Architectural Review
and Historic Preservation Board
Agenda Report

File: AR 15-32

RE: Surf Thru Express Car Wash – Vacant Lot at Southwest Corner of Forest Avenue
and Notre Dame Blvd. – APN 002-190-038

PROPOSED SITE PLAN

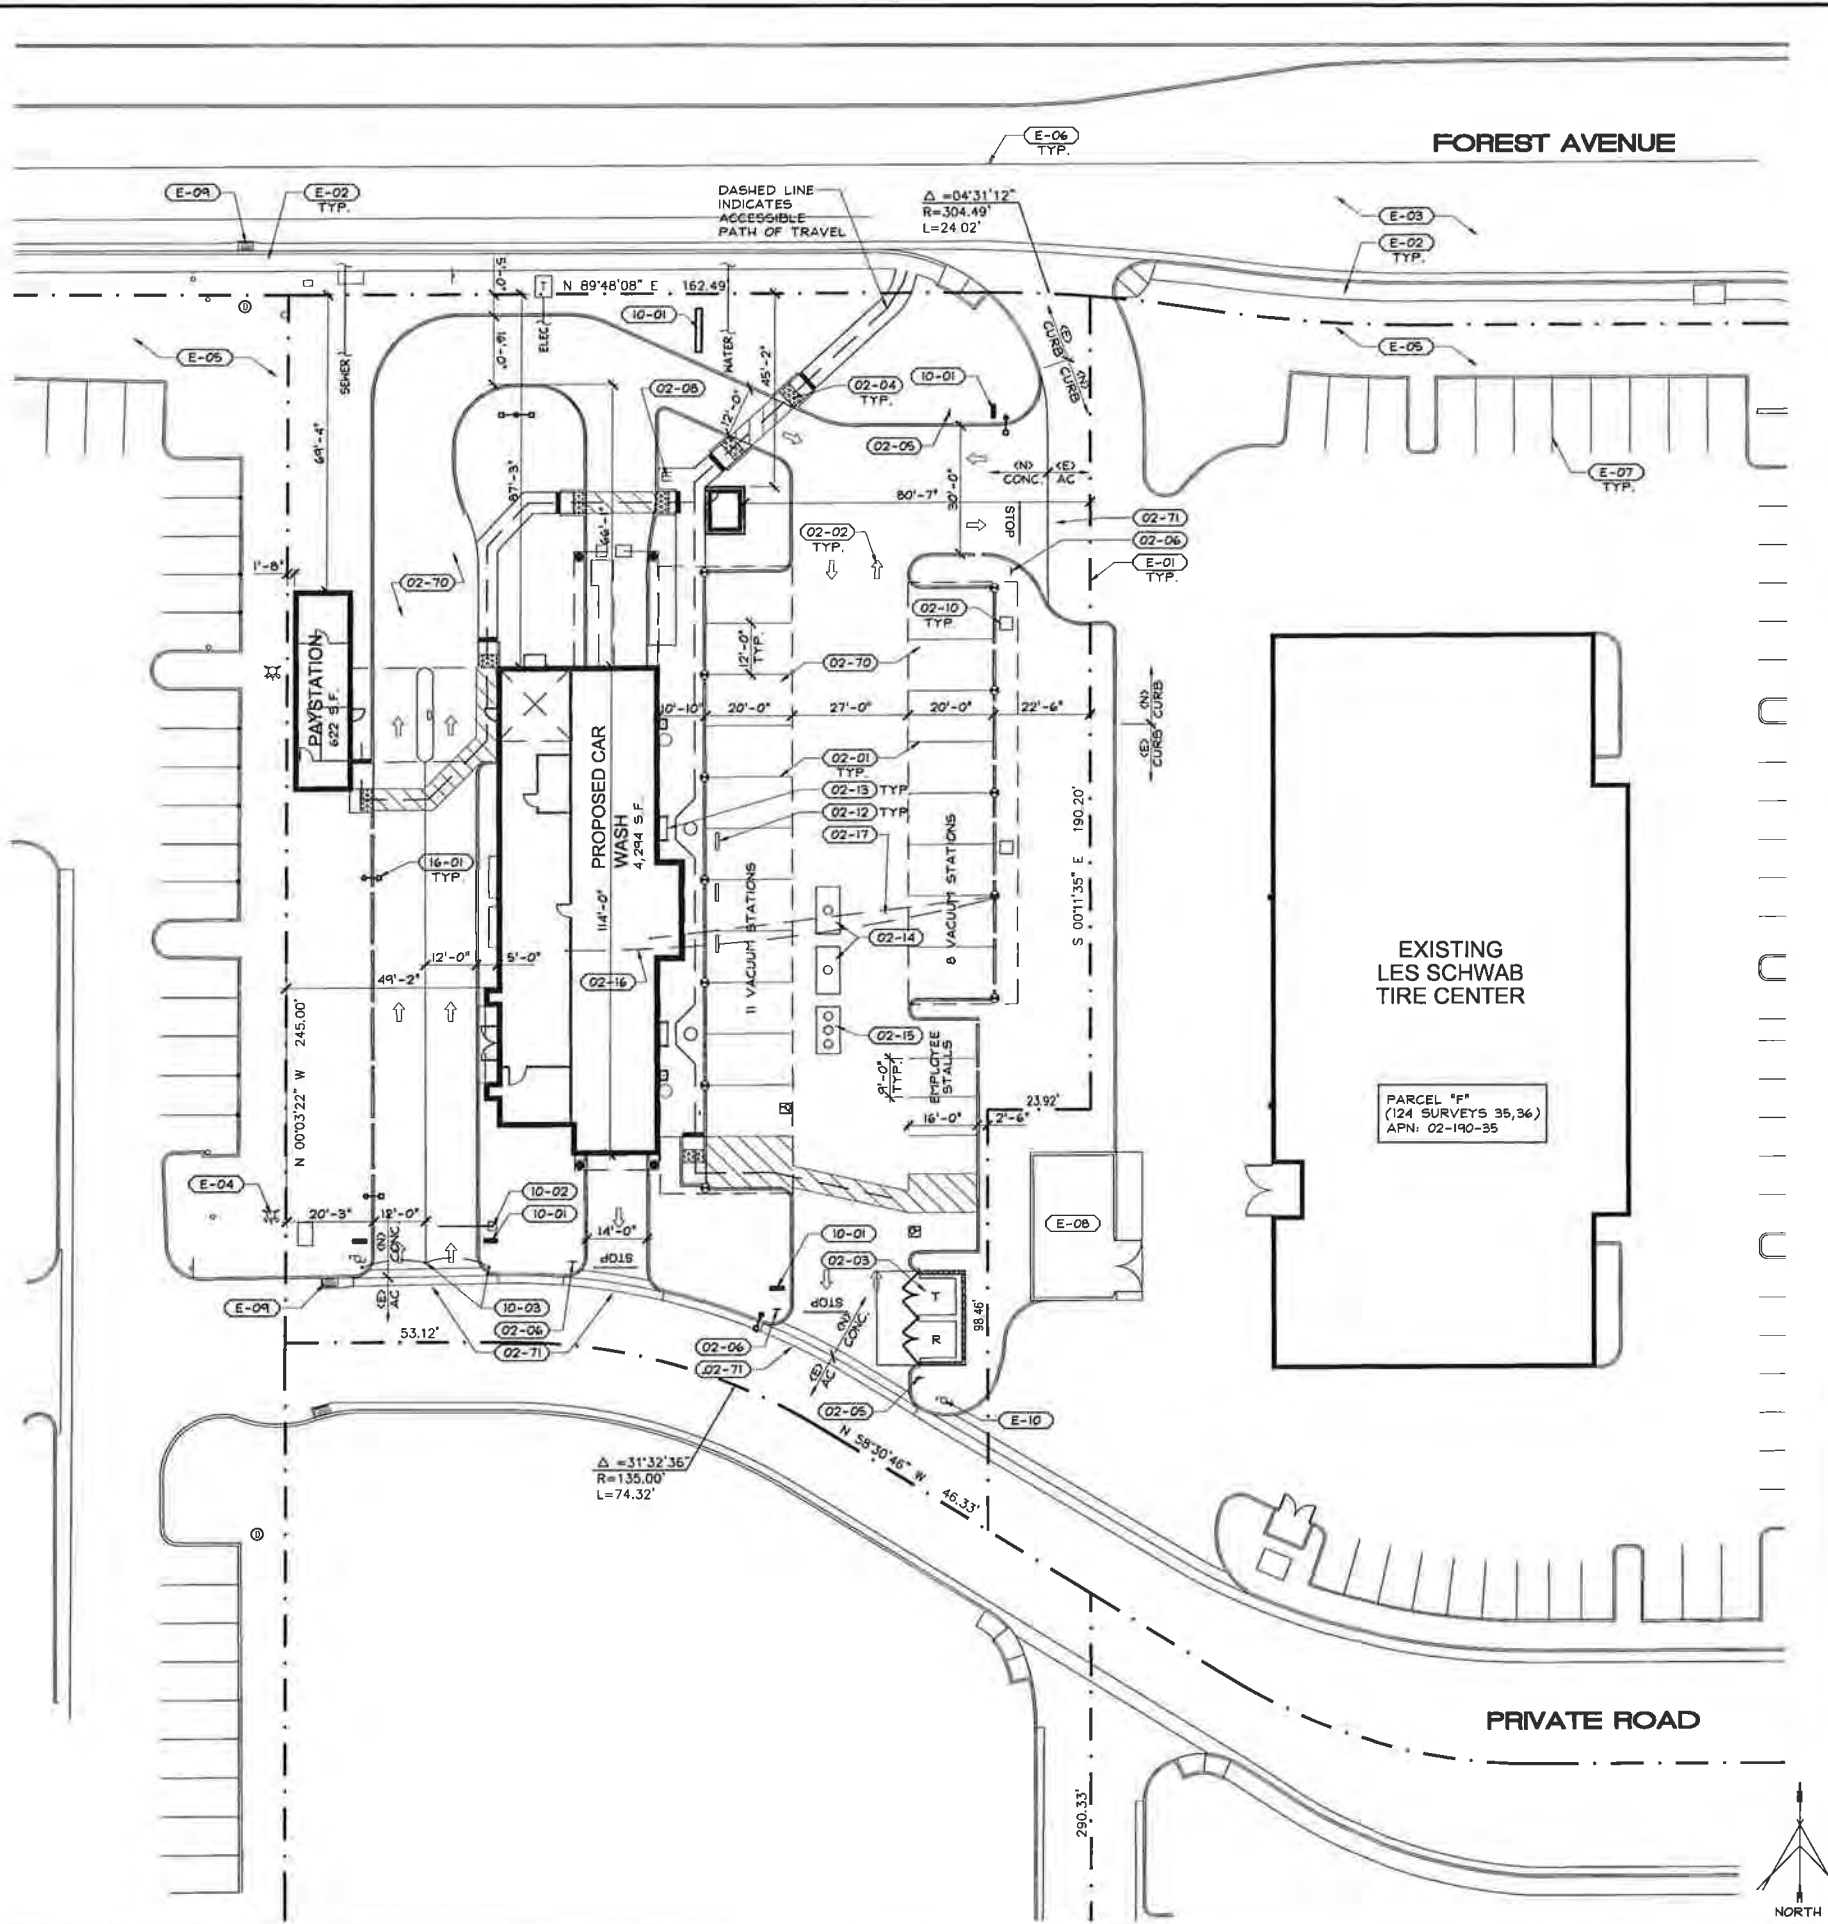
Chico Municipal Code section 19.76.070.G. – *Drive-through Facilities*, requires each drive-through aisle shall be designed to include a combination of landscaping, low walls and or berms to prevent headlight glare and to reduce visibility from impacting adjacent streets. Landscaping is present along Forest Avenue frontage, however, it does not contain a low wall or berm. Staff recommends that the board discuss with the applicant appropriate design modifications to satisfy this code section.

Screening of the drive-through does not meet code requirements which require the combination of landscaping, low walls or a berm to prevent headlights and reduce visibility from the public right-of-way. Staff request that the board discuss with the applicant a design solution to meet code requirements.

Shrubs and/or a two-foot high concrete masonry unit (CMU) wall will be added to block the cueing lines of cars at the entrance end (street side) to the car wash tunnel. Trees and shrubs matching neighboring parcels will be provided in the landscape frontage shielding vehicles from the public right-of-way, quantity and size designed per city code standard. The trash bins will be located within a 6 foot tall CMU enclosure with metal gates, along with necessary landscaping tall enough to soften the trash enclosure walls.

PROPOSED EXTERIOR ELEVATIONS

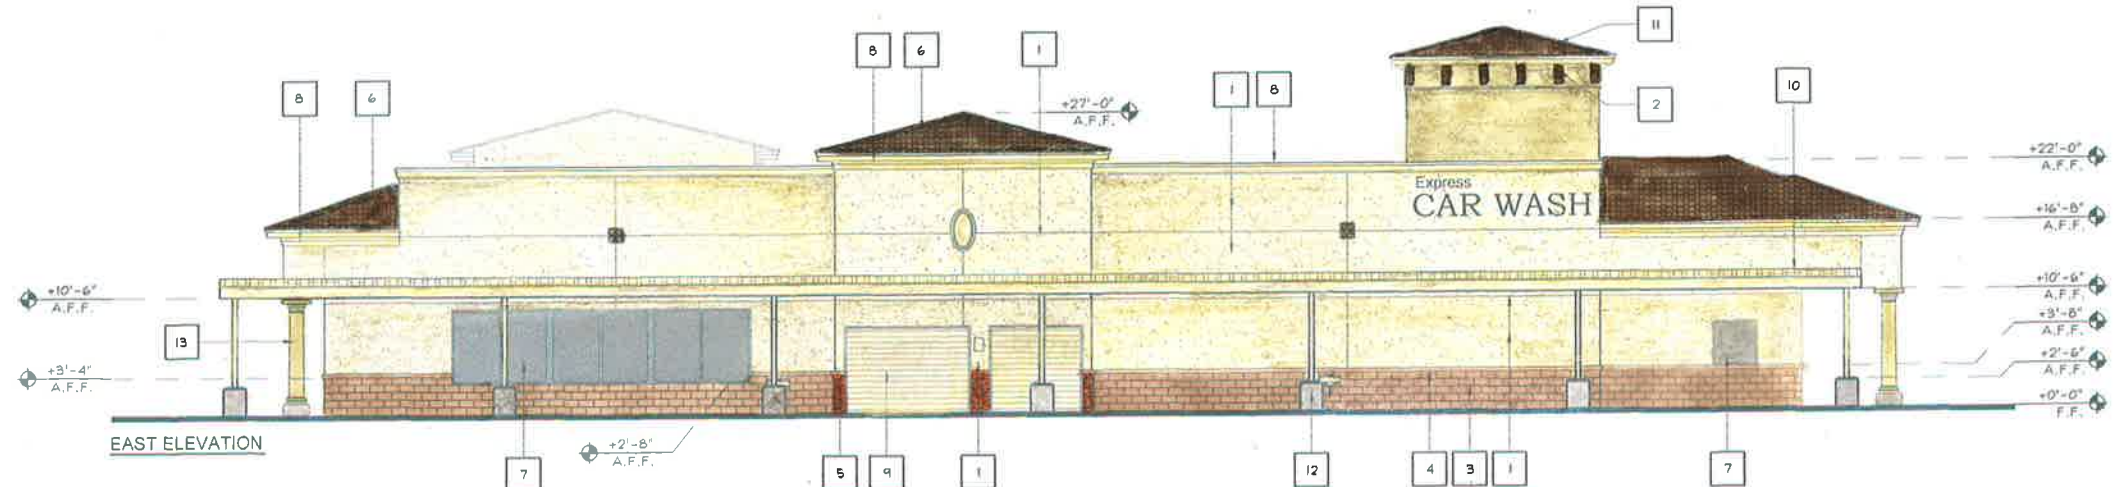
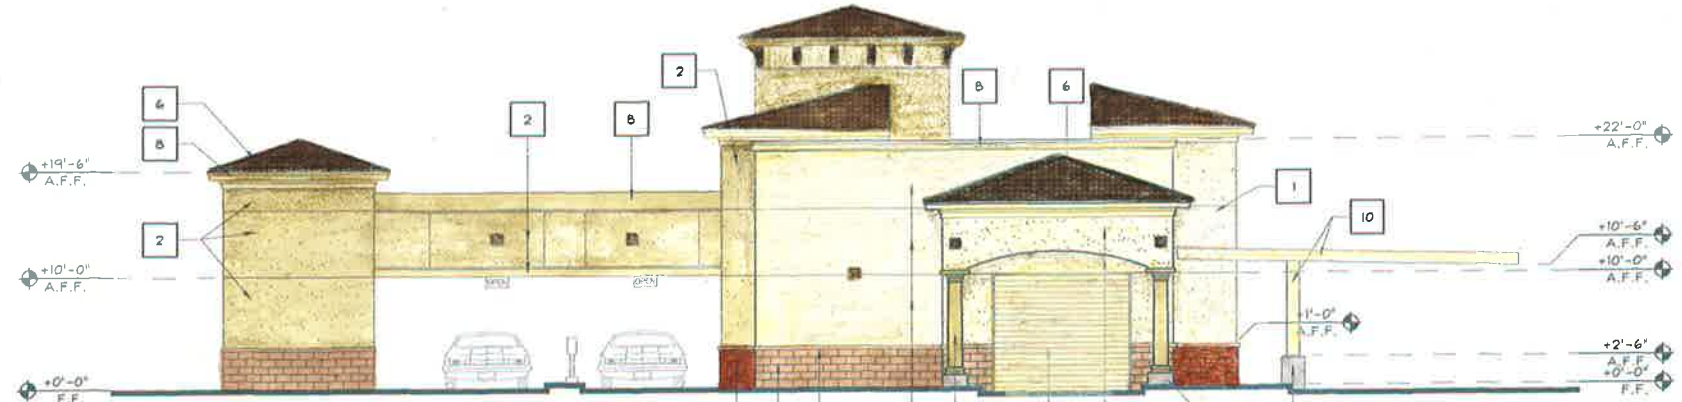
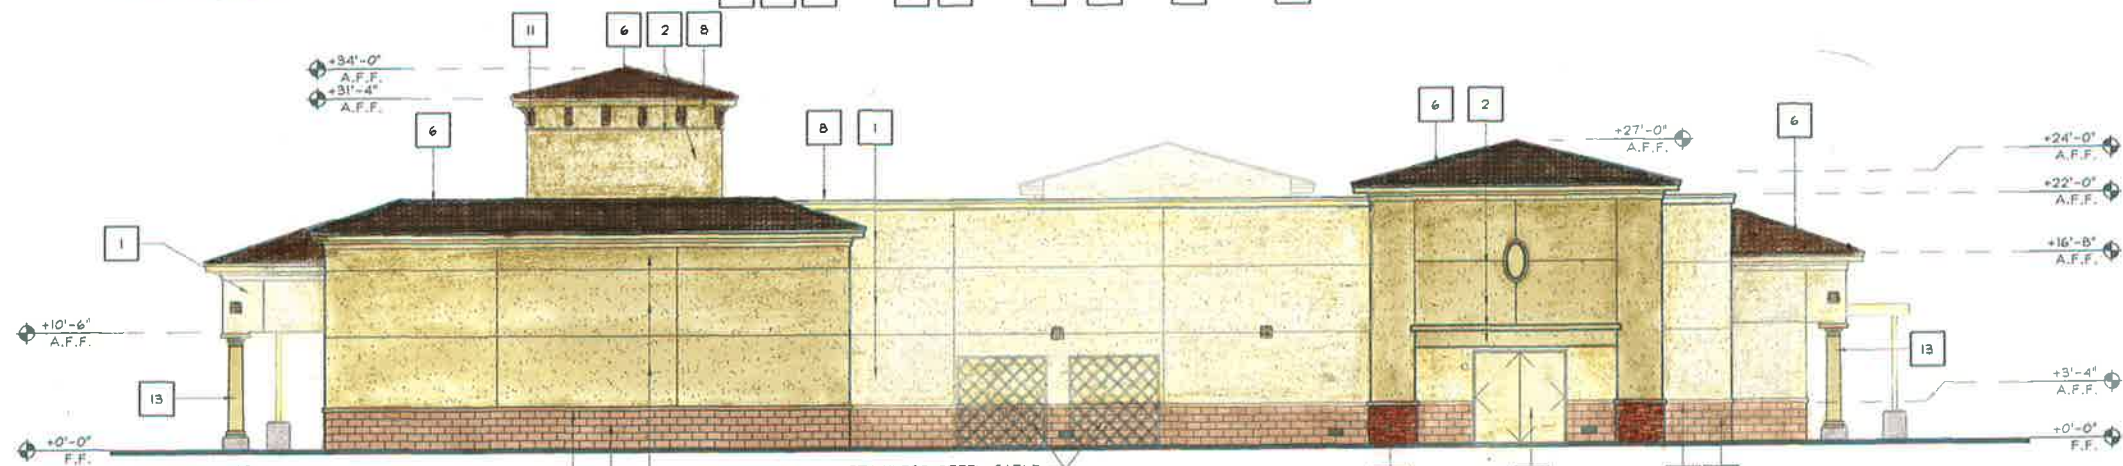
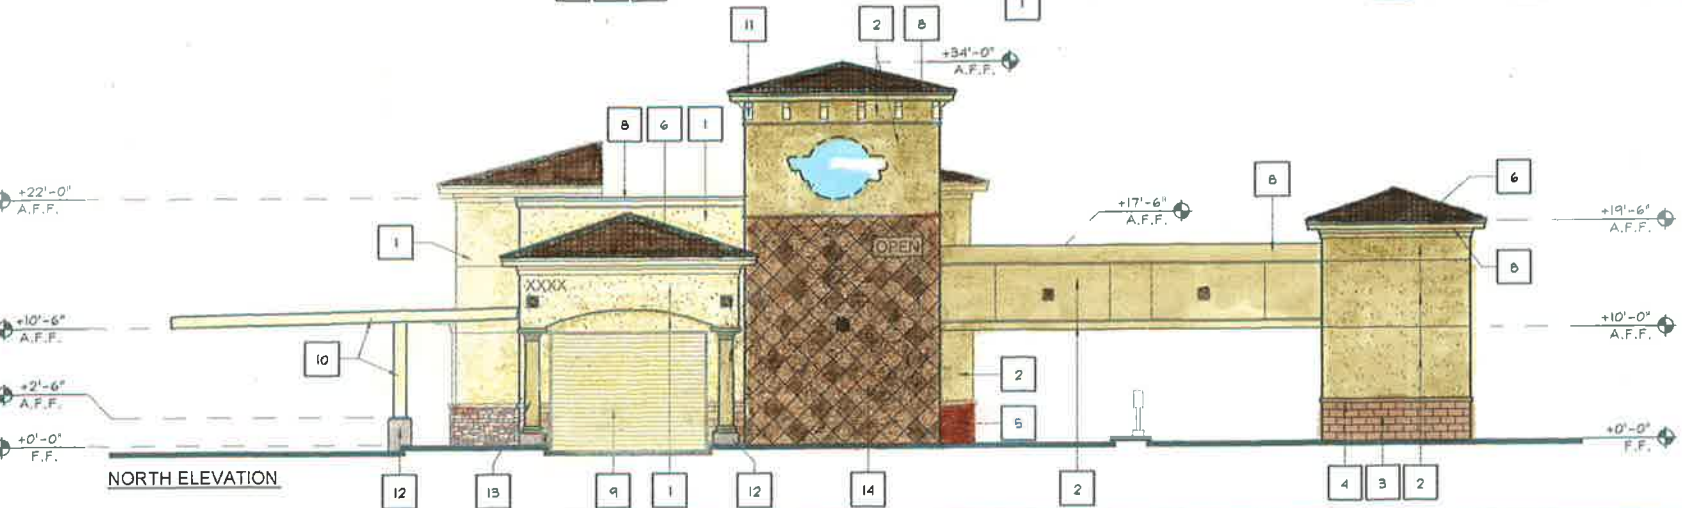
The Mediterranean building style offers continuity throughout all four elevations in both colors and materials. Design details include split face block around all elevations, with brick veneer to add additional interest. Additional accents are proposed with square tiles and medallions around the upper portions of the structure. The project is consistent with Design Guidelines (DGs) that call for architectural significant aspects of the structure to take precedence (DGs 2.1.27).

The roof design contains a variety of depths and heights that creates additional interest. The project avoids flat roofs through the introduction of metal canopies, a tower element with corbels, parapet cap and concrete tiles (DG 2.2.24, 2.2.25). A lighting plan is provided which outlines the location of all structural lighting and lights poles (see **Attachment F**). Each symbol on the light plan correspond to a specific light detail. However, the proposed height of the lighting is not indicated. Therefore, staff recommends a condition of approval that wall lighting shall be mounted at an appropriate height, and parking lot lighting shall be mounted at a pedestrian scale not to exceed 16 feet.

Located on the western elevation, the pay station does not contain any window treatments that can be seen from the public right of way. Staff request that the board discuss with the applicant the possibility of including window elements on either the western or northern elevations of the pay station.

1. All approved building plans and permits shall note on the cover sheet that the project shall comply with AR 15-32 (Surf Thru Carwash). No building permits related to this approval shall be finalized without authorization of Planning staff.
2. All wall-mounted utilities and roof or wall penetrations, including vent stacks, utility boxes, exhaust vents, gas meters and similar equipment, shall be screened by appropriate materials and colors. Adequate screening shall be verified by Planning staff prior to issuance of a certificate of occupancy.
3. All parapet caps and other metal flashing shall be painted, consistent with the approved building colors.

ATTACHMENT G

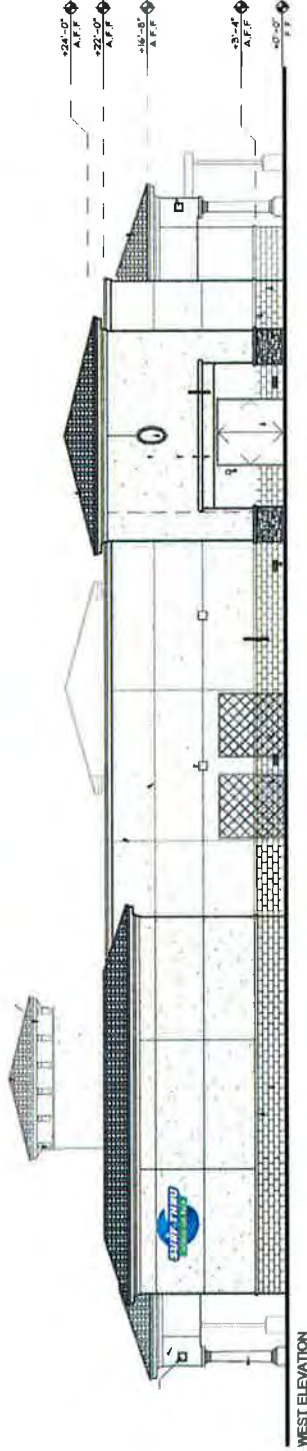
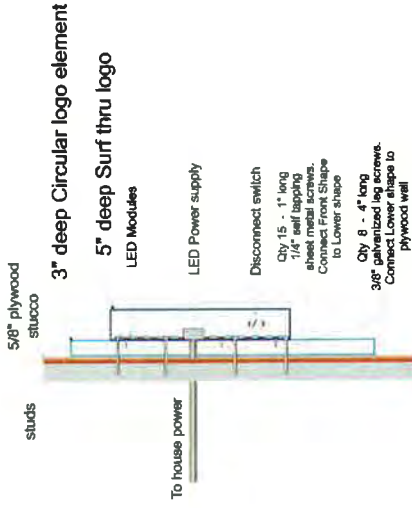
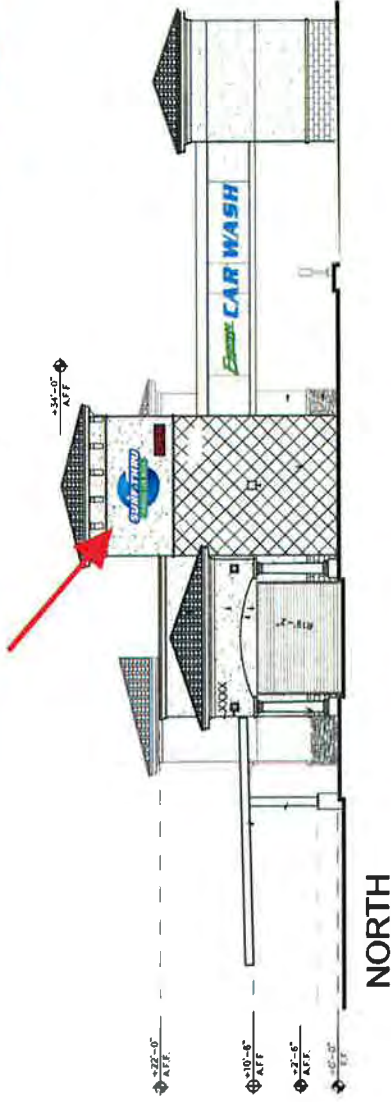
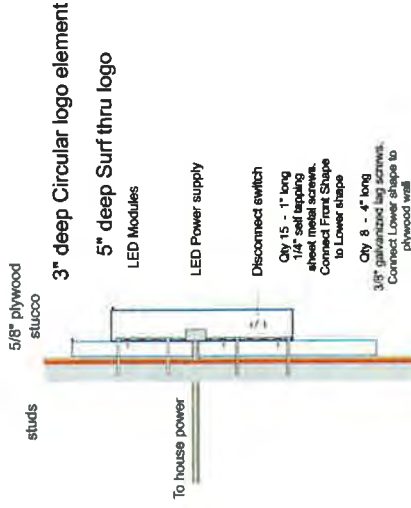
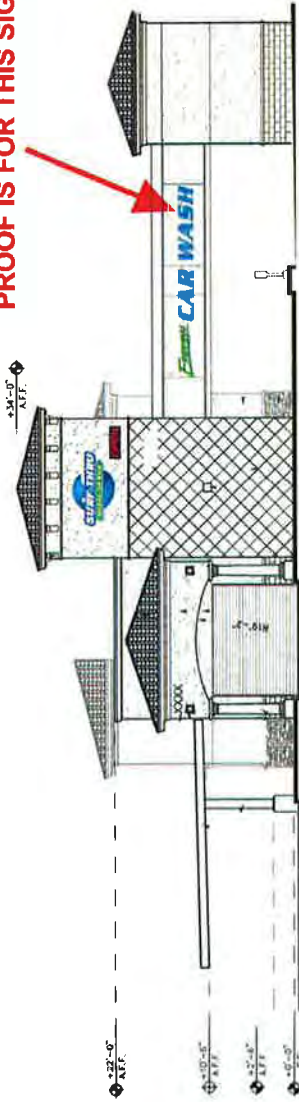
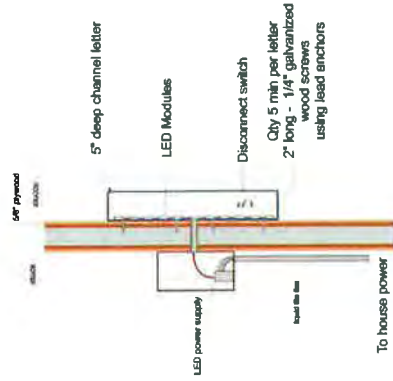
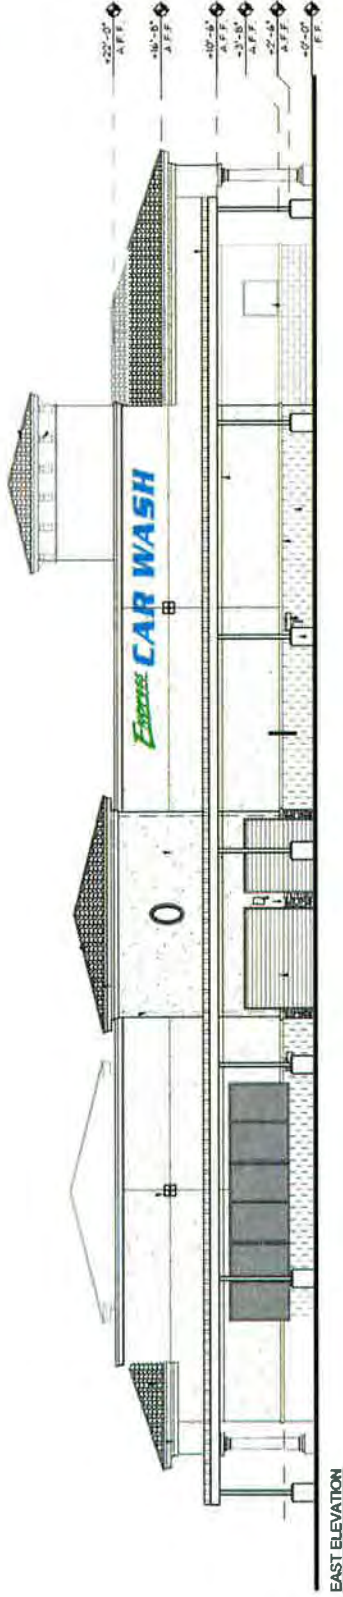
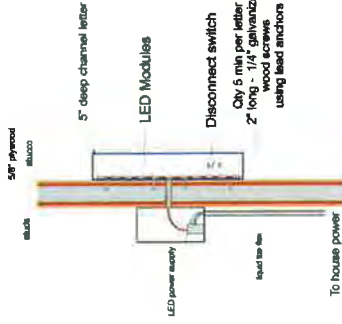
Sign package has been submitted, which notes signage will be internally illuminated flush mounted channel letters (**Attachment G**). Structural signage is proposed on the north elevation, as well as the west and east elevations. A 10-foot tall monument sign is proposed along the Forest Avenue street frontage. Staff recommends that the proposed monument sign not to exceed 6-feet in height and be placed in a dedicated landscape planter per Chico Municipal Code (CMC) requirements. Pursuant to CMC section 19.74 – Signs, a total of 228 square footage of sign area is allowed (2 square foot per 1 foot of linear building frontage) for all signs. The sign proposed exceeds requirements at 289 square footage of sign area. Therefore, staff has placed a condition of approval requiring signage to conform to code requirements and approved by planning staff.

4. Sign package shall be revised to conform to the 228 square footage maximum as set forth in Chico Municipal Code section 19.74. Monument sign not to exceed 6-feet in height and shall be placed in a landscape planter. Future signage shall be reviewed and approved by planning services staff prior to issuance of a sign permit.
5. Wall lighting shall be mounted at an appropriate height, and parking lot lighting shall be mounted at a pedestrian scale not to exceed 16 feet.
